IDAP REPORT – SECTION 4.55(1A) MODIFICATION

Property:	14 Wentworth Street, Greenacre Lot 2 DP 36122 DA2020.154.2
Proposal:	S4.55(1A) Modification Application involving alterations and additions to the approved dual occupancy and construction of an in-ground swimming pool with attached outbuilding.
Applicant:	ZTA Group
Owner:	Z Abdul Rahman
Date of lodgement:	20 April 2021
Notification period:	27 April 2021 to 11 May 2021
Submissions received:	N/A
Assessment officer:	P Santos
Estimated cost of works:	\$940,653.00
Zoning:	R2-Low Density Residential - SLEP 2012
Heritage:	N/A
Flood affected:	Yes
RECOMMENDATION OF OFFICER:	APPROVAL

Figure 2A. Extract of the proposed basement in the subject modification application.

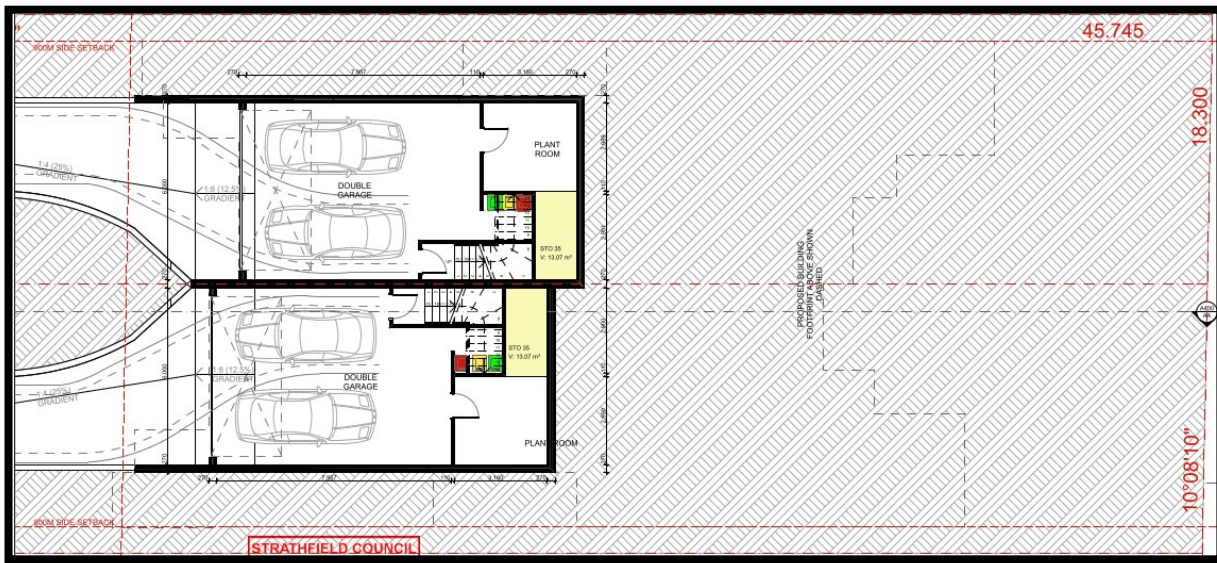
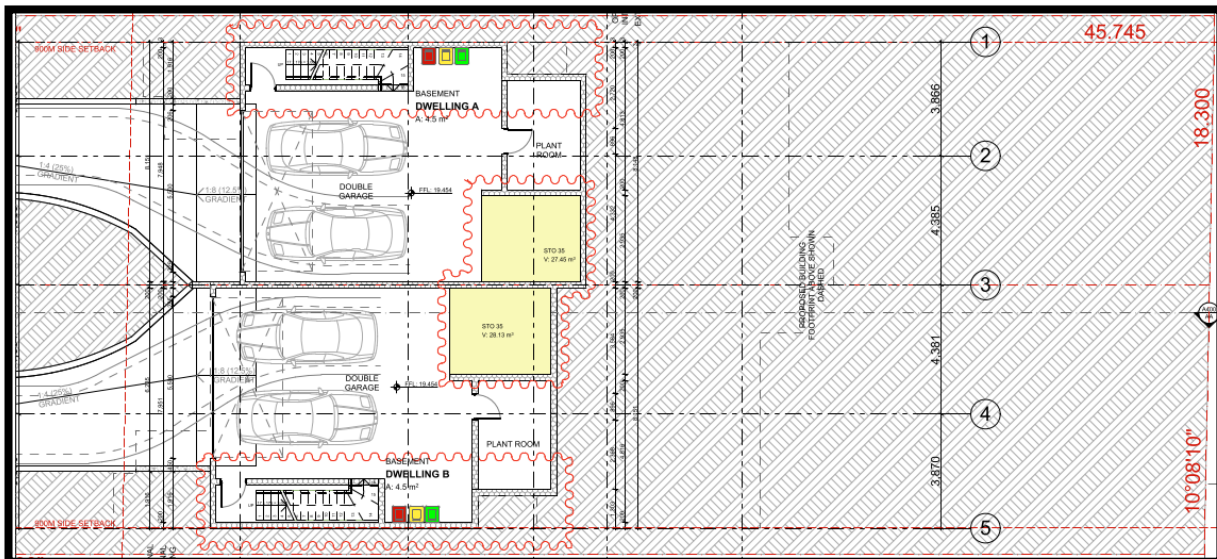
- Addition to the basement footprint.

Figure 3A. Extract of the proposed ground floor plan in the subject modification application.

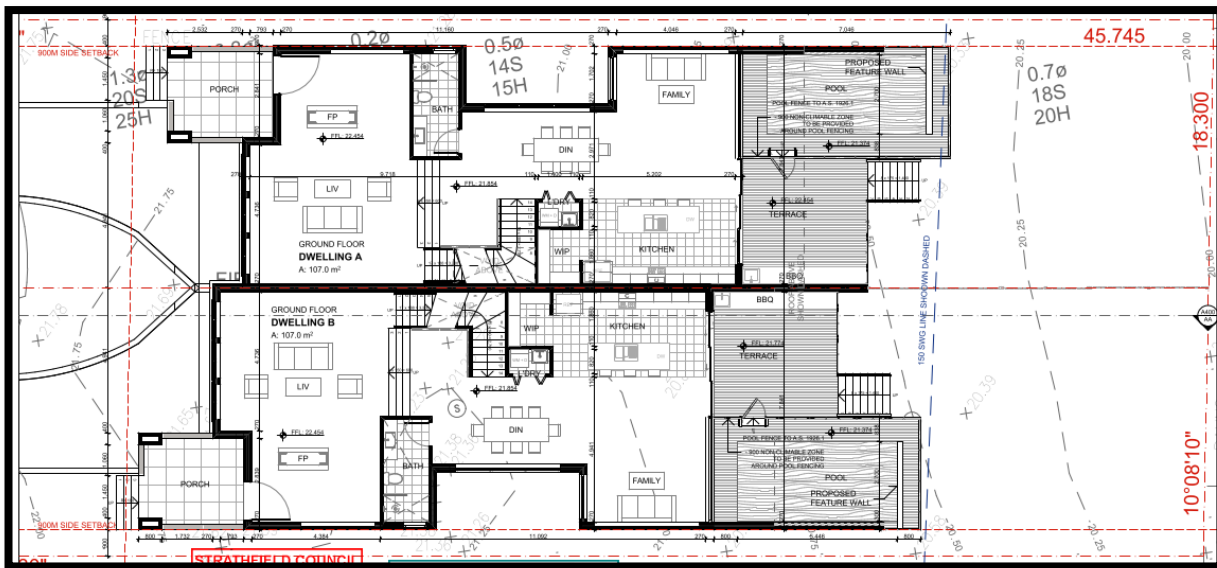
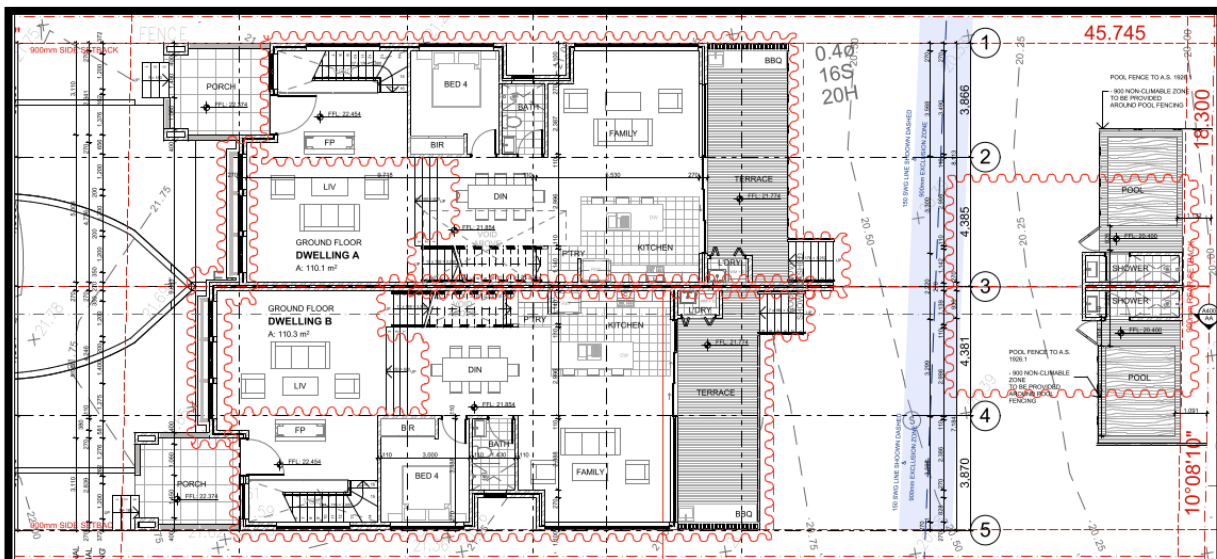
- An additional bedroom,
- Reduction in depth,
- Addition of a laundry room,
- Increase in alfresco size, and
- Removal of the attached swimming pool.

Figure 4A. Extract of the proposed first floor in the subject modification application.

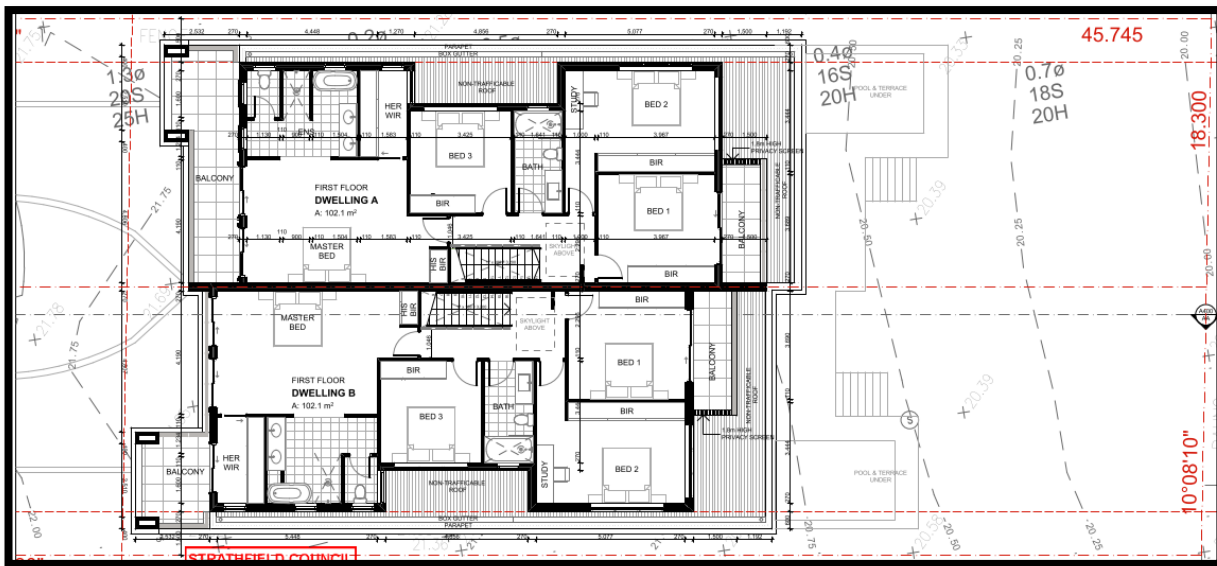
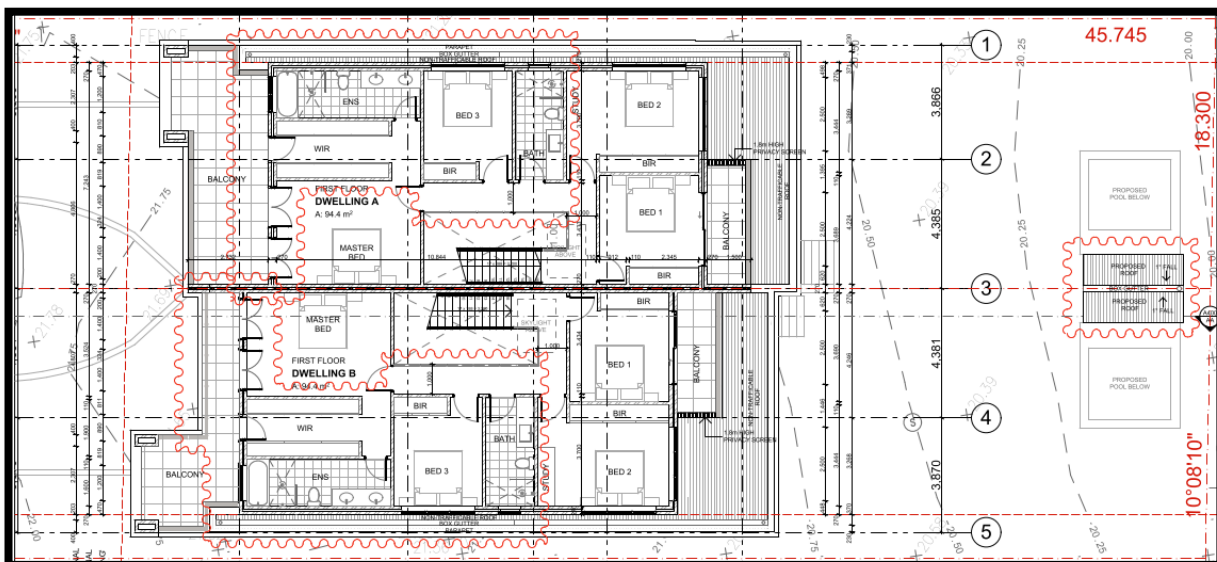
- Dwelling A
 - Increase in size of the front balcony due to the reduction of master bedroom area, and
 - Filling-in of the articulated section.
- Dwelling B
 - Extension of the front balcony, covering the whole façade of Dwelling B, due to the reduction of master bedroom area, and
 - Filling-in of the articulated section.
